CITY OF SHEBOYGAN APPLICATION FOR CONDITIONAL USE PERMIT Requirements Per Section 15.905

Narrative for Conditional Use Permit (CUP) Walmart Store 1276 (Sheboygan) Project No. 21165 3711 S Taylor Dr. Sheboygan, WI 53081

Good morning. On behalf of Walmart Stores Inc., LK Architecture, as an authorized agent, present for your consideration, a Conditional Use Permit (CUP) Application for Walmart Store 1276 located at 3711 S Taylor Dr. Sheboygan, WI.

PHOTOMETRICS PLAN

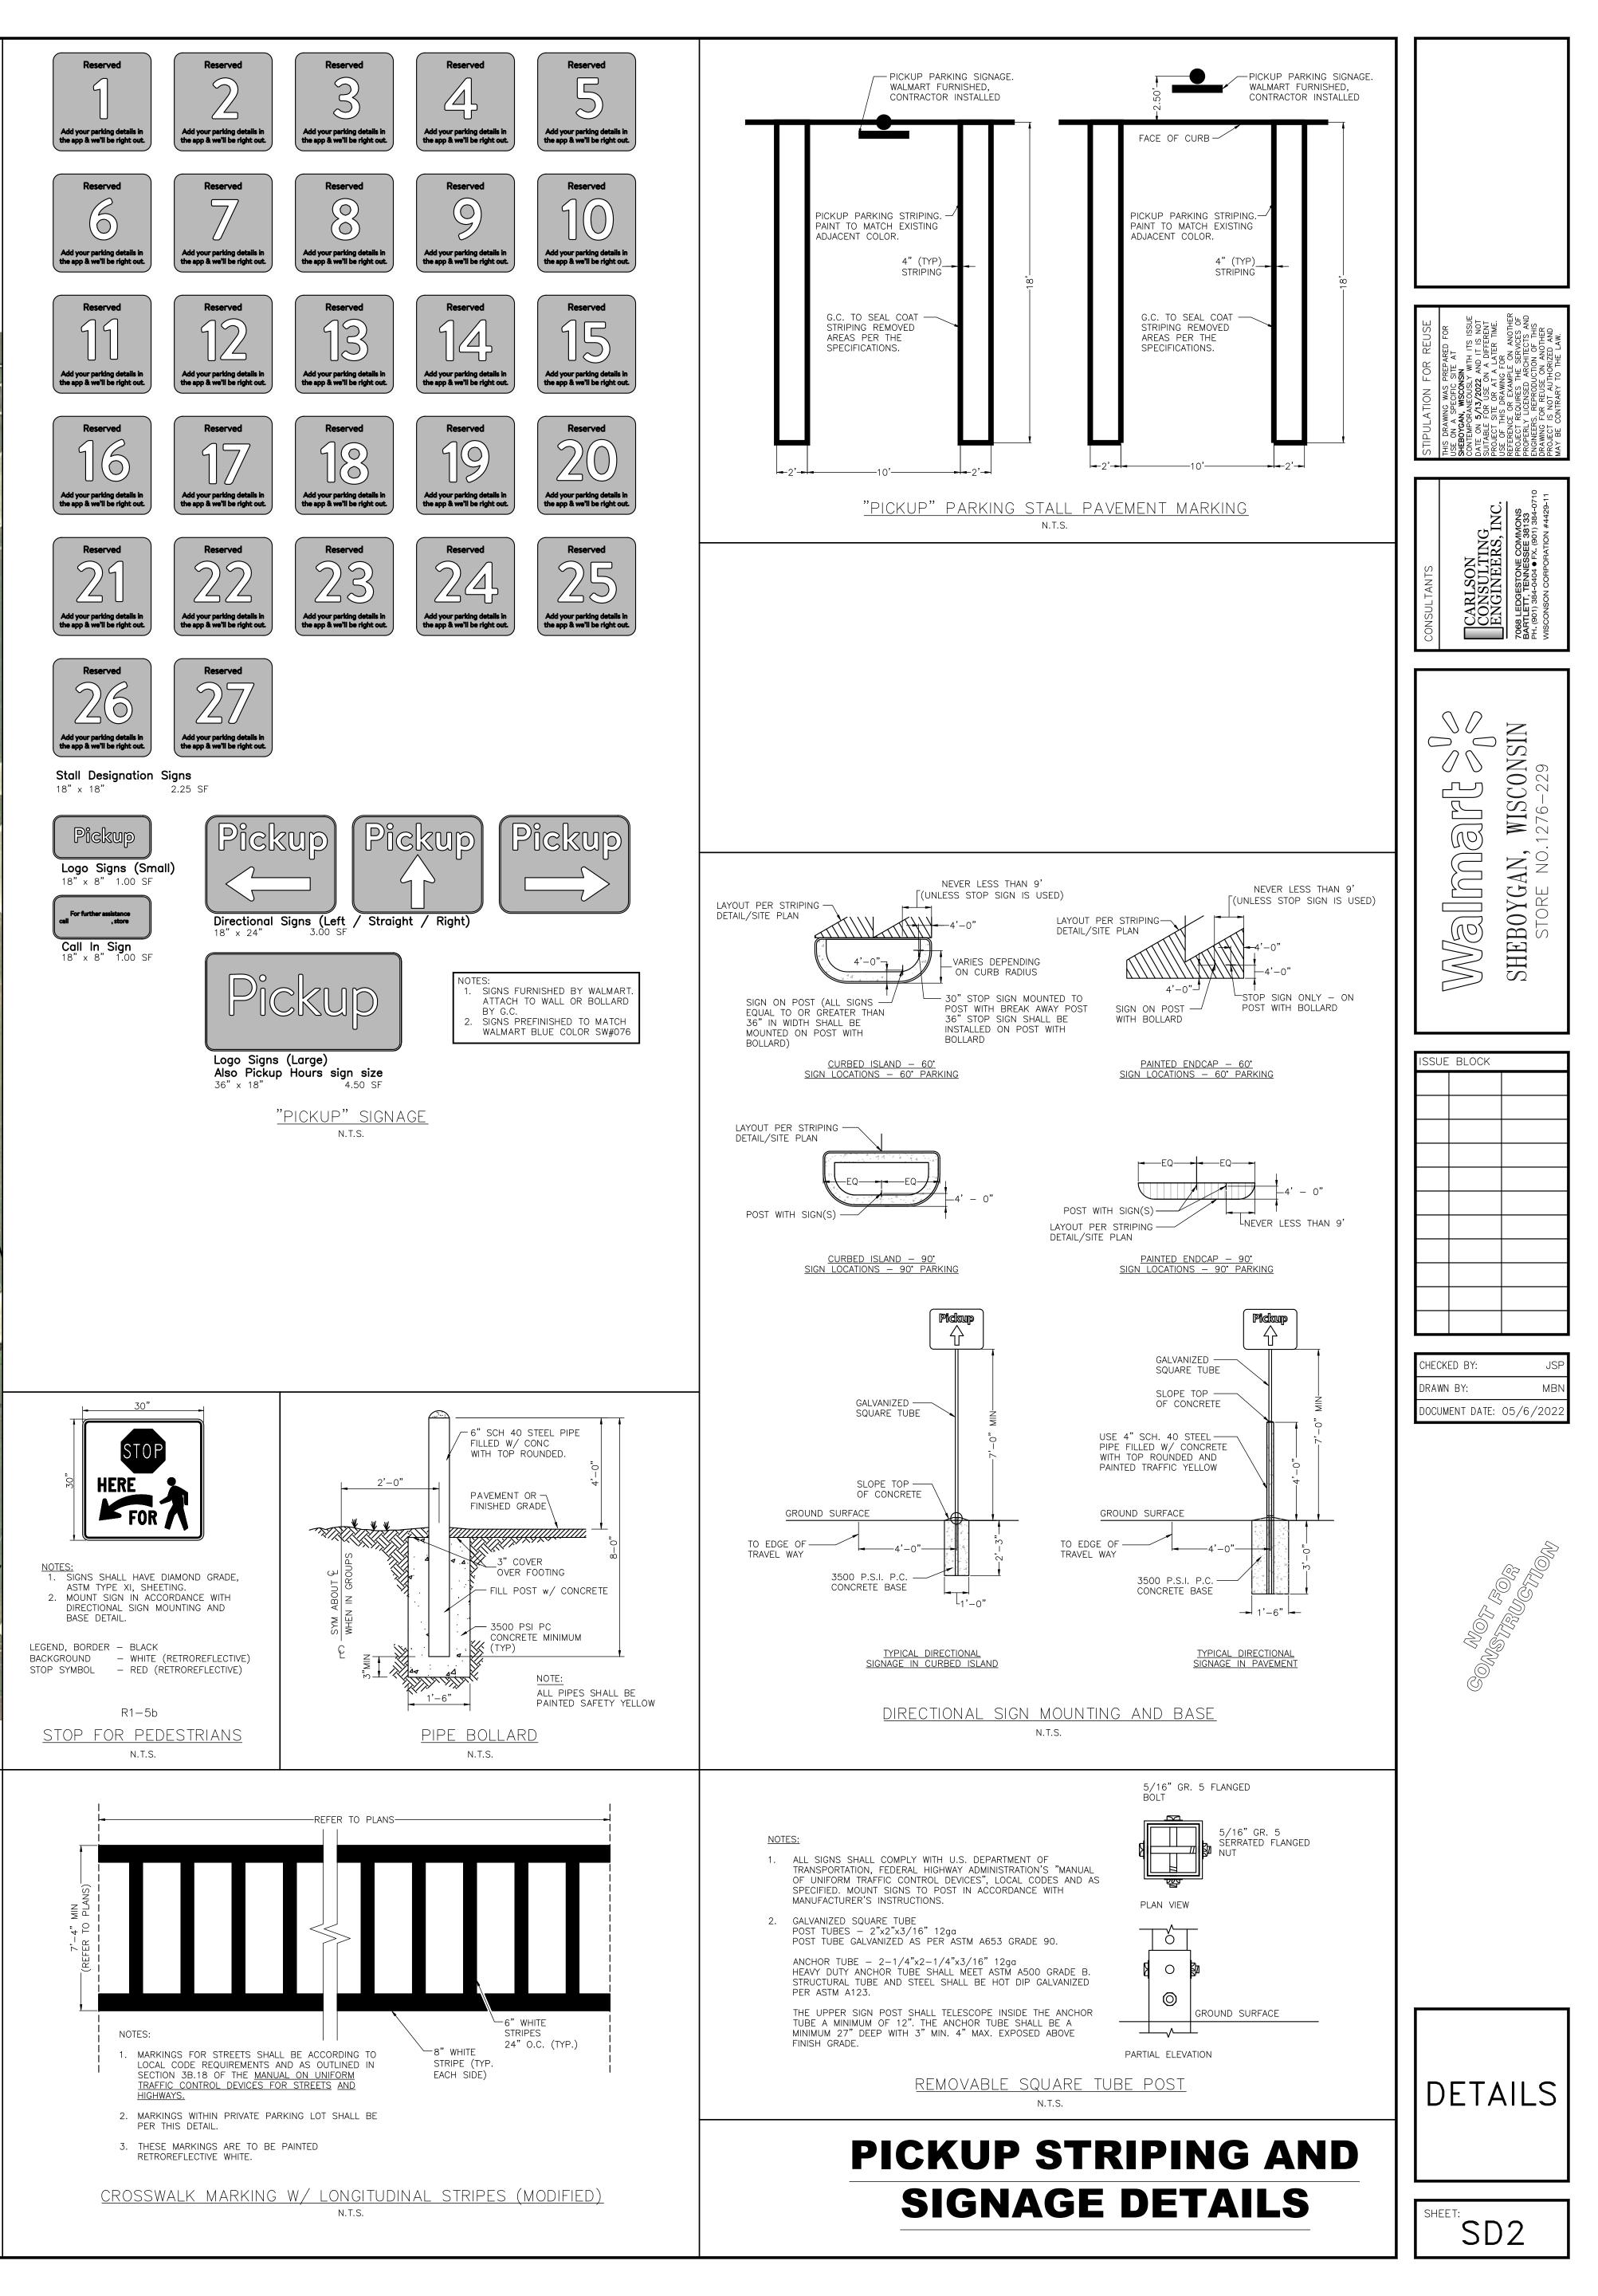
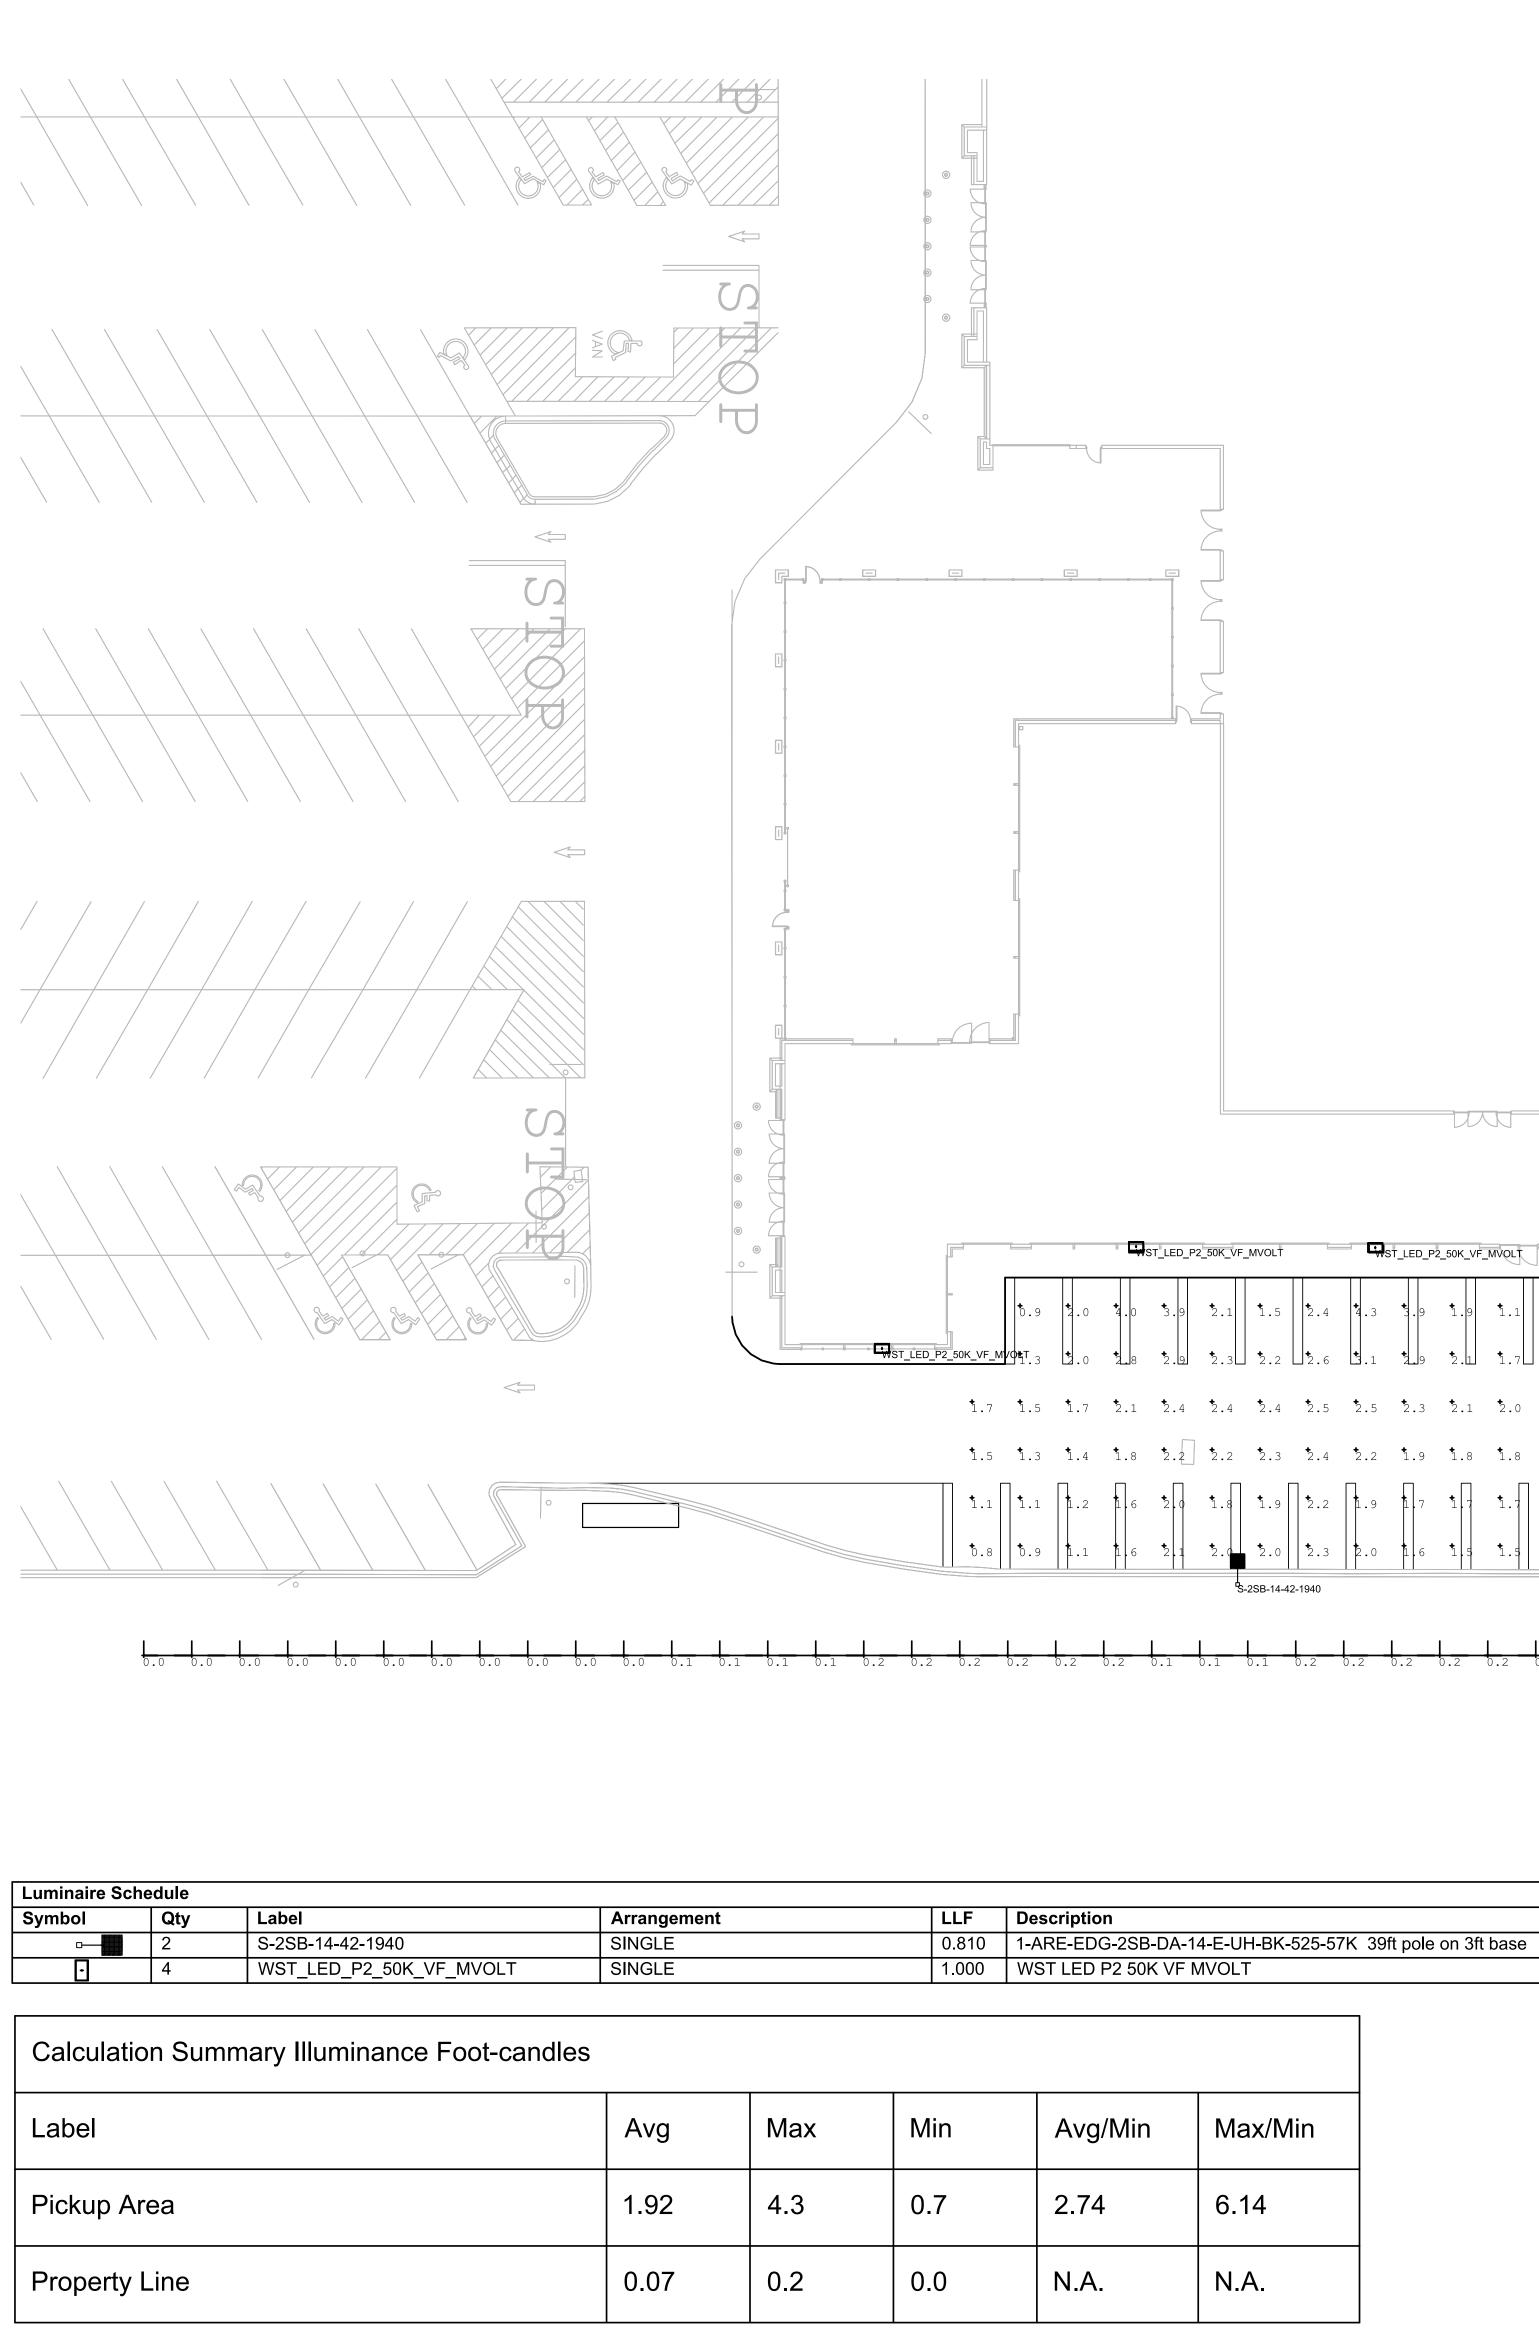
• Are you adding any additional parking lot lighting.....lighting cannot spill over onto adjacent properties, especially the area of the new pickup parking? Please provide details on new lighting poles.

Two new light poles and fixtures will be added south of the existing curb line to provide an average of 2.0 footcandles in the Pickup area. The vertical footcandles were also evaluated along the southern property line at a height of 5'. Footcandles along the property line will be 0.2 or less which is well below typical suburban requirements at property lines. Please reference exhibit (SD3 – Photometric Plan) for lighting location and (Lighting Pole Base Detail) for details.
